# UNITED STATES PATENT AND TRADEMARK OFFICE

APPLICATION NO.	FILING DATE	FIRST NAMED INVENTOR	ATTORNEY DOCKET NO.	CONFIRMATION NO.
10/785,008	02/25/2004	Ho Gyeong Yun	123034-05004911	9730
43569	7590	08/31/2005	EXAMINER	
MAYER, BROWN, ROWE & MAW LLP 1909 K STREET, N.W. WASHINGTON, DC 20006			PENG, CHARLIE YU	
			ART UNIT	PAPER NUMBER

<b>Office Action Summary</b>	<b>Application No.</b>	<b>Applicant(s)</b>	
	10/785,008	YUN ET AL.	
	<b>Examiner</b>	<b>Art Unit</b>	
	Charlie Peng	2883

FIG. 1 (a)

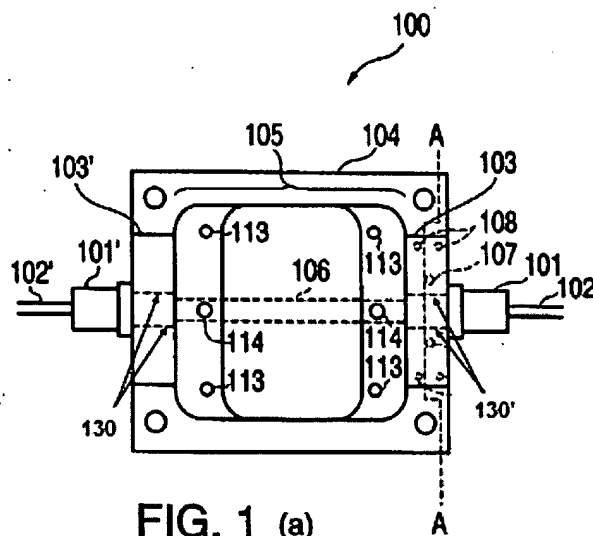
Claims 1-16 are rejected under 35 U.S.C. 103(a) as being unpatentable over U.S. PGPub 2002/0146227 to Suzuki et al. Suzuki et al. teaches an optical collimator module **100** that has a base member **104** (i.e., a bottom surface) with two holding members **103, 103'** (i.e., two outer walls), the two holding members **103, 103'** each has a hole (as indicated by the dashed lines **130, 130'** on included drawing Fig. 1(a) having additional labels by the examiner) with optical collimators **101, 101'** and optical cables **102, 102'** inserted therein, and wherein the three members form a U-shape. (See at least Fig. 1 and its description.) Although Suzuki et al. do not specifically place an optical device on the bottom surface, combining such a part is obvious and also disclosed in review of prior art by Suzuki et al., wherein an optical functional component **205**, in a similar U-shaped optical collimator module, is placed in a beam path **106** between two collimators/fiber cables. It would therefore have been obvious to one of ordinary skill in the art at the time the invention was made to place a functional optical component in the optical module by Suzuki et al. The motivation would be to enable optical functions such as switching (via a filter, a mirror, etc.), optical signal receiving (via a photodiode), or optical signal transmitting (via a laser, an LED, etc.)

With specific references to claims 2, 4, 6, 8, 10, 12, 14, and 16, it is immediately obvious from at least Fig. 1(a) and its description in Suzuki et al. that the two outer walls 103, 103' are of different due to the fact that the outer wall 103 are shortened so screws 107, 108 can be placed between the outer wall 103 and the bottom surface.

FIG. 4 (a)

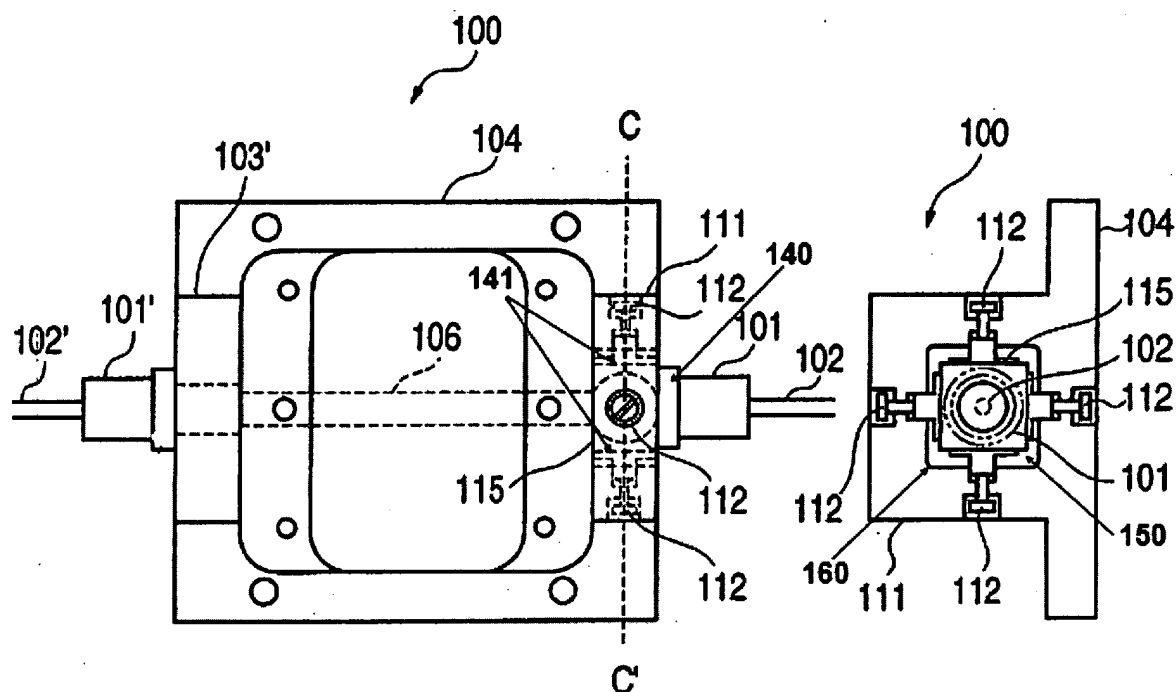
With specific reference to claims 9 and 11, Suzuki et al. teach a ring 140 encircling the first collimator 101. The ring is also outlined by dashed lines 141 and placed within a hole 160 of an outer wall 111 of the base member 104. The hole 160 is substantially different in shape (square) and size from a second hole, in which the second collimator 101' is inserted. (See at least included drawing Figs. 4(a) and 4(b) having additional labels by the examiner and description.) A space 150 exists inside the hole 160, wherein alignment of the collimator 101 can be made by adjusting screws 112.
